**WATTS BAR NUCLEAR PLANT (WBN) UNIT 1 - REQUEST FOR ADDITIONAL  
INFORMATION FOR END-OF-CYCLE 6 STEAM GENERATOR INSERVICE  
INSPECTION REPORTS (TAC NO. MC7485)**

### WATTS BAR NUCLEAR PLANT (WBN) UNIT 1 REQUEST FOR ADDITIONAL INFORMATION END-OF-CYCLE 6 STEAM GENERATOR 15 AND 90 DAY INSERVICE INSPECTION REPORTS

FIGURE 1

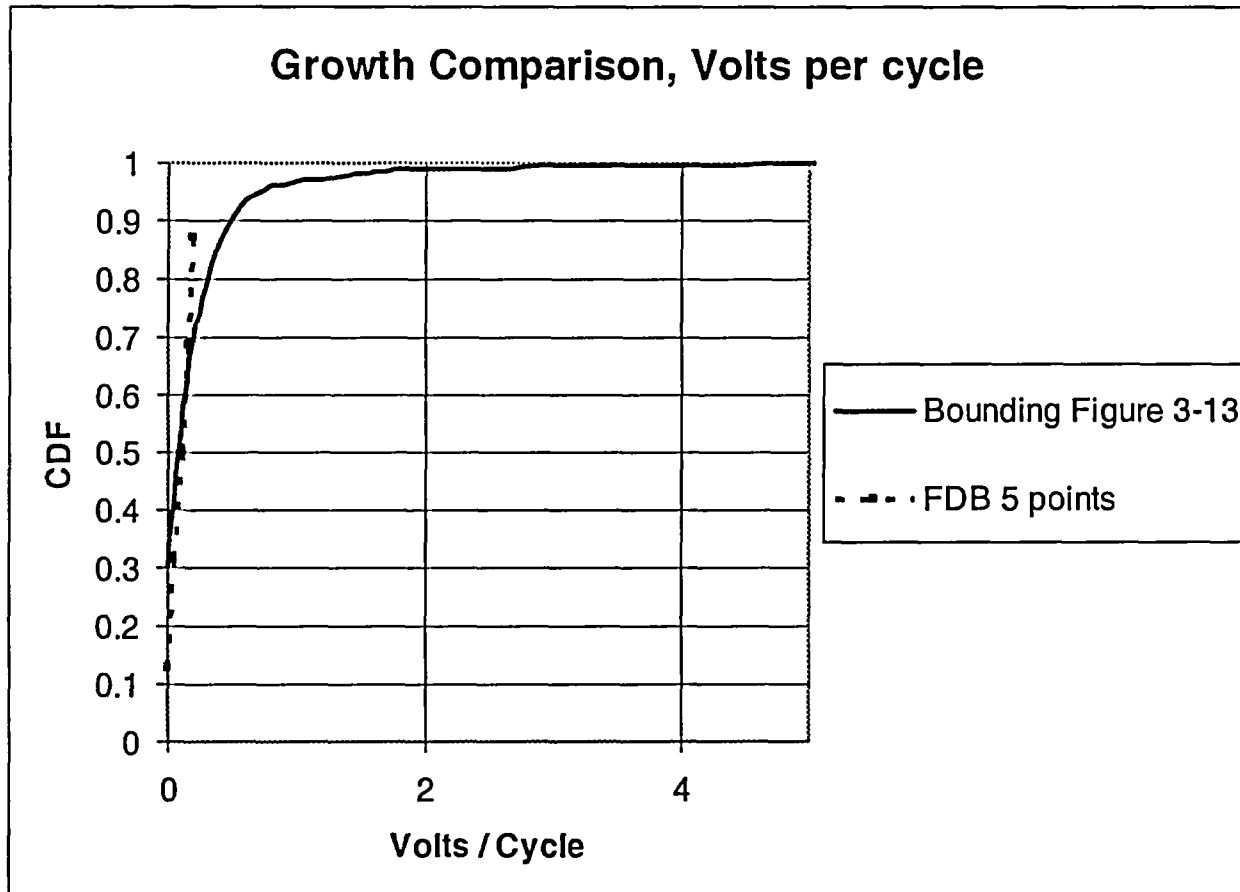
In your June 28, 2005 letter, it was indicated that several of the tubes remaining in service contained indications located where the tube passes through the flow distribution baffle. Please confirm that your amendment request for implementing the voltage-based tube repair criteria discussed in Generic Letter (GL) 95-05 addressed the conditions in Section 2.a.3 of Attachment 1 to GL 95-05 (since specific U.S. Nuclear Regulatory Commission (NRC) approval is needed to apply the voltage-based limits to flow distribution baffle intersections).

- a) That is, confirm that your amendment request addressed the causal factors for high voltage growth at flow distribution baffle intersections and the applicability of these conditions at your plant. Also,
- b) please discuss whether the average growth rates for the flow distribution baffle indications were less than that observed in steam generator 3 (although page 3-18 indicates that the average growth rates are less than that seen in steam generators 1 and 2, flow distribution baffle indications were found in steam generators 1, 2, and 3). If not, please discuss the implications.

A better demonstration of the observation that the growth rates are not considerably different is a comparison with the bounding cumulative distribution of the growth rate in the four steam generators shown in Figure 1 below and in Figure 3-13 in the June 28, 2005 report. Also shown is the cumulative distribution of the FDB indications conservatively adjusted by Benard's approximation equation (Note 1) because of the small number of data points.

From the figure, it is clear that the growth rate of the FDB indications is not considerably different from the growth rate of the TSPs.

FIGURE 6-2  
3/4-INCH BURST PRESSURE CORRELATION

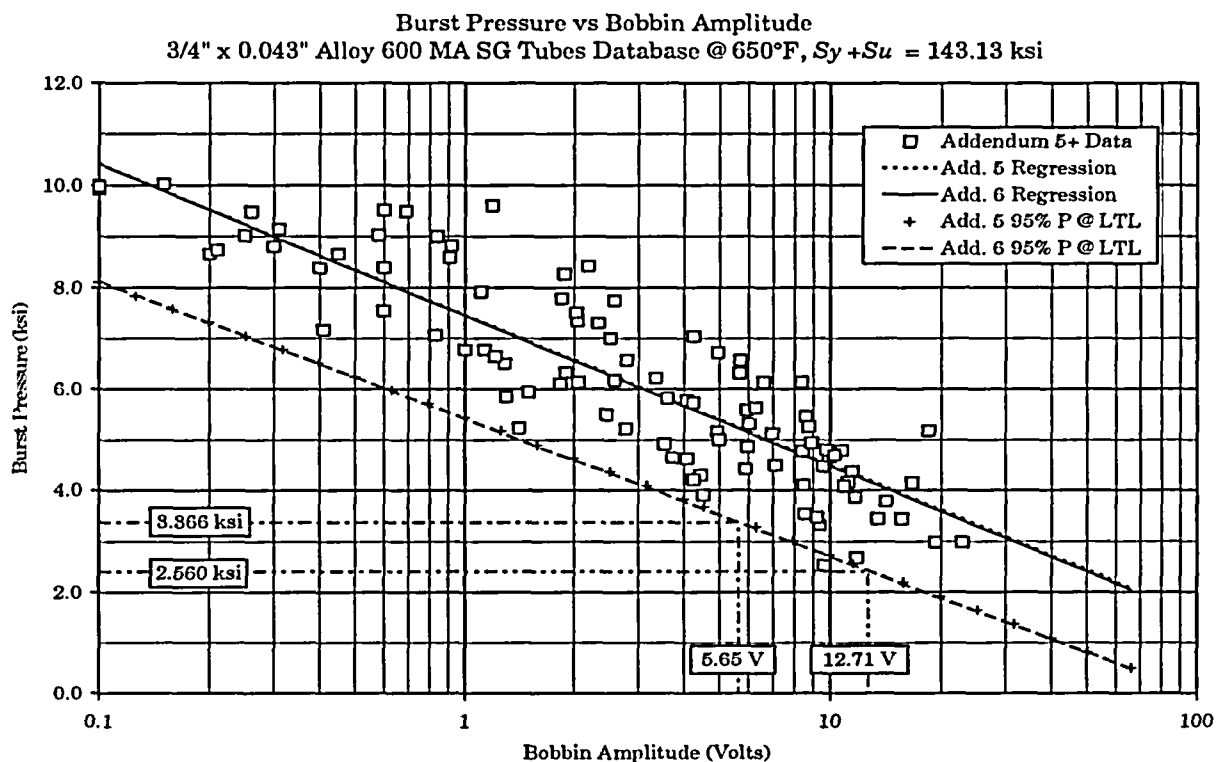
*One tube was identified with a 6.32 volt indication. Please discuss what actions, if any, were taken to ensure that this tube had adequate structural integrity since the voltage exceeded the structural limit of 5.65 volts.*

There is no requirement to do single-tube structural integrity calculations. The requirement in GL 95-05 is for a probability of burst for the bundle. This indication was included in the bundle analysis, and the steam generator met structural

performance criteria. Therefore, no additional actions were taken. If a single tube is of interest, according to Figure 6-2 of Addendum 6 of EPRI Report NP-7480-L shown below, an indication greater than 12 volts would be expected to meet the steam line break pressure with 95 percent probability using 95/95 lower tolerance limit material properties. The 5.65 limit in the Addendum is used as an upper bound repair limit. Above this limit, rotating coil examination cannot be used to keep the indication in service. Below this limit, if rotating pancake coil (RPC) does not confirm the indication, the tube can be left in service.

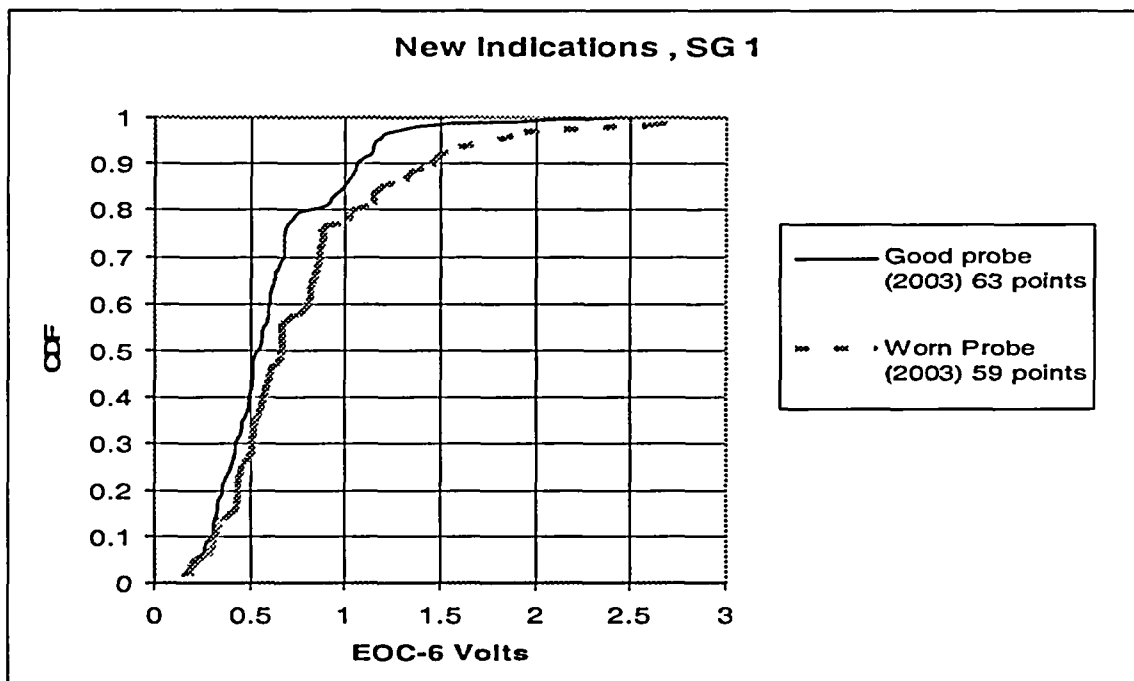
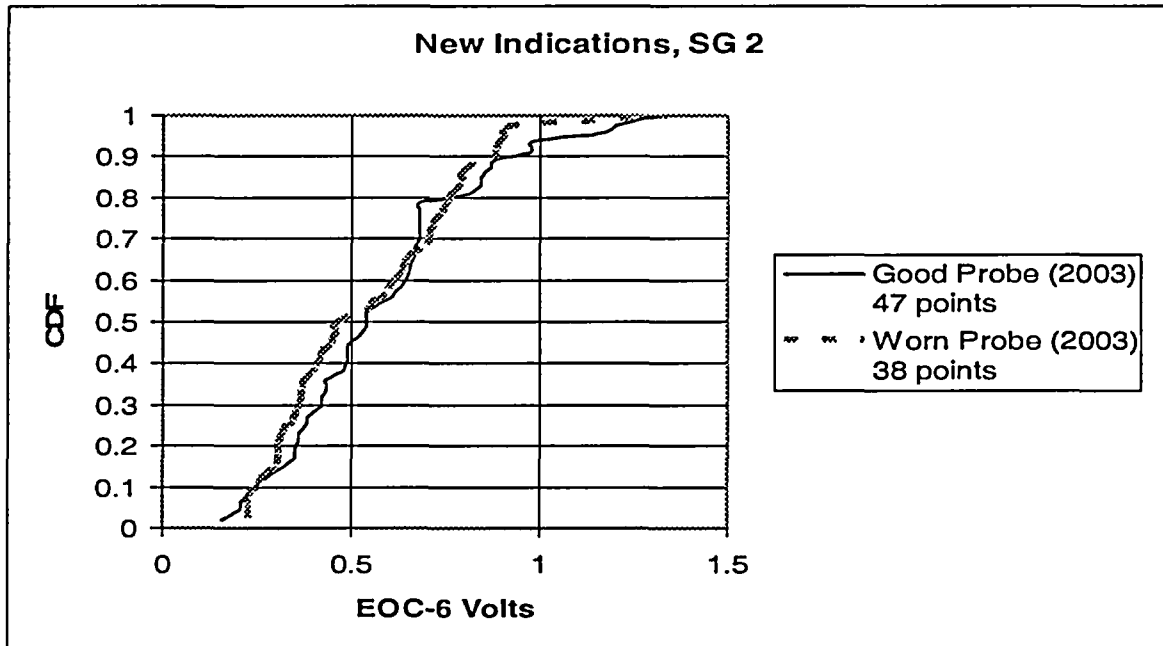
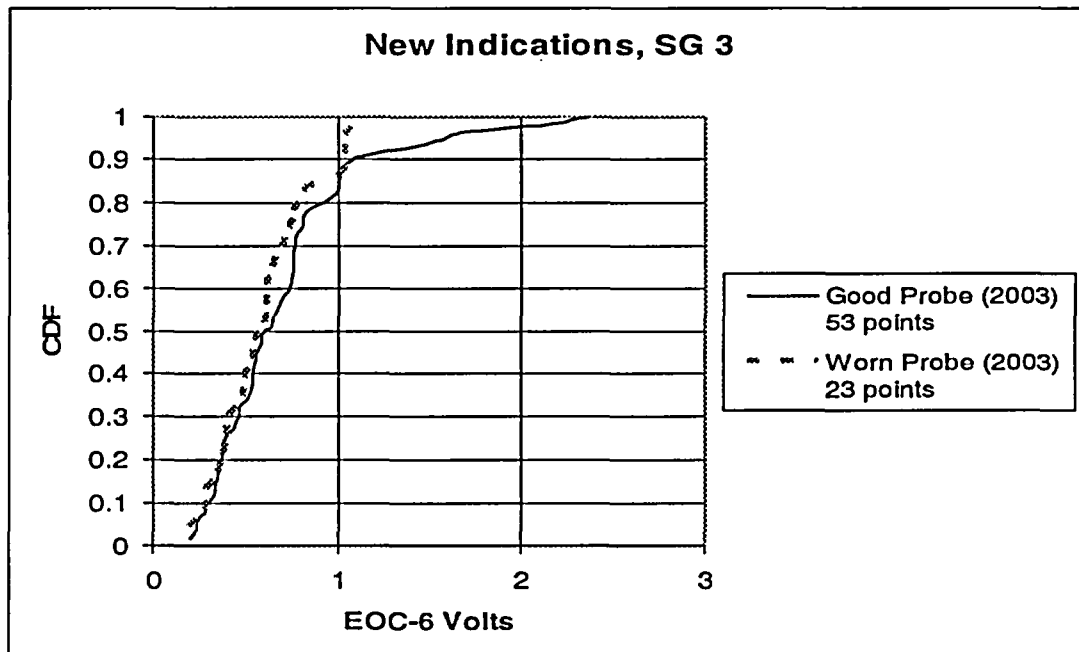
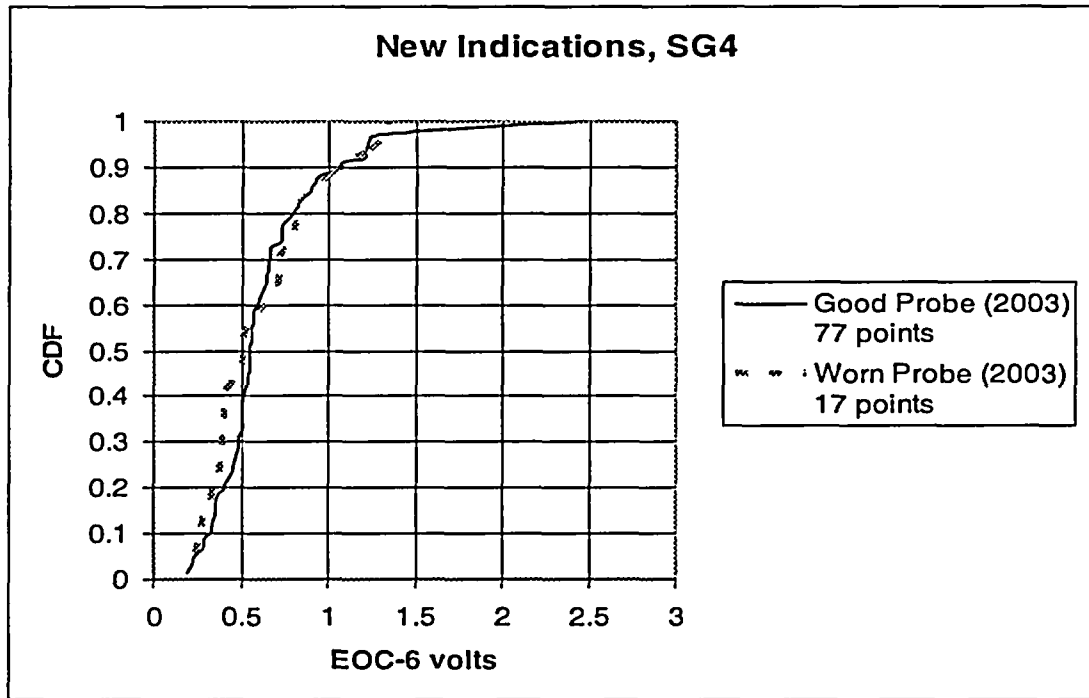
Section 4.7 provides an assessment of the probe wear criteria used at Watts Bar. In a portion of this assessment, the ratio of the current number of indications greater than 1 volt to the total number of these indications that were inspected with a worn probe in the previous inspection was compared to the ratio of the number of indications greater than 1 volt to the total number of indications in the current inspection. Based on similar ratios, a conclusion was drawn that there was no significant effect of probe wear on the population of indications. The staff notes that such a comparison is only valid if the number of tubes inspected with both a worn and good probe is comparable. That is, if the number of tubes inspected with worn probes is significantly different from the number of tubes inspected with a good probe, an erroneous conclusion may be made with respect to the adequacy of the probe wear criteria. As a result, please compare the percentage of new indications at the end-of-cycle (EOC) 6 that were inspected with a worn probe during the EOC-5 inspection to the percentage of new indications that were inspected with a good probe during the EOC-5 inspection. In addition, please compare the percentage of new indications greater than or equal to 0.5 volts during the EOC-6 inspection that were inspected with a worn probe during the EOC-5 inspection to the percentage of new indications greater than or equal to 0.5 volts during the EOC-6 inspection that were inspection with a good probe during the EOC-5 inspection. If there are significant differences, please provide an assessment of the adequacy of the probe wear criteria and its impact on your operational assessment for EOC-7. Calculation of the above percentages requires the

The voltage distributions of the new indications are shown in Figures 1 through 4 for Steam Generators 1 through 4 respectively.

The voltage magnitude of the new indications in tubes previously tested with worn probes and good probes is essentially the same as seen in Figures 1 through 4. This further supports the position that significant differences in results are not occurring due to previous testing.
